ATTENTION: GENERAL MANAGER PARTS MANAGER CLAIMS PERSONNEL SERVICE MANAGER	IMPORTANT - All Service Personnel Should Read and Initial in the boxes provided, right. © 2022 Subaru of				TIN		SL 7 DRIVI		
APPLICABILI SUBJE	2022 BRZ Body Rep	2			1111	Ν	IUMBE DAT	 12-234 02/28

This Service Information Bulletin announces additional information for the 2022MY BRZ Body Repair Manual. This information supplies added detail for roof panel replacement. It is IMPORTANT to fully review this bulletin prior to performing any roof panel replacement on 22MY BRZ.

BODY REPAIR MANUAL REVISION INFORMATION:

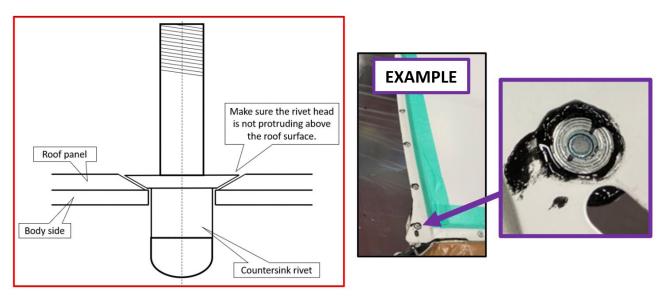
In locations where countersunk rivets are used, drill a pilot hole of 6.5 mm [0.26 in] in diameter. ٠ With the roof panel removed from the vehicle, taper the hole to a diameter of 12 mm [0.47 in] with a taper of 120° so the rivet head does not protrude above the roof panel. See images below.

• Treat the cut remaining shaft of the rivet so it does not protrude above the rivet head. See images below.
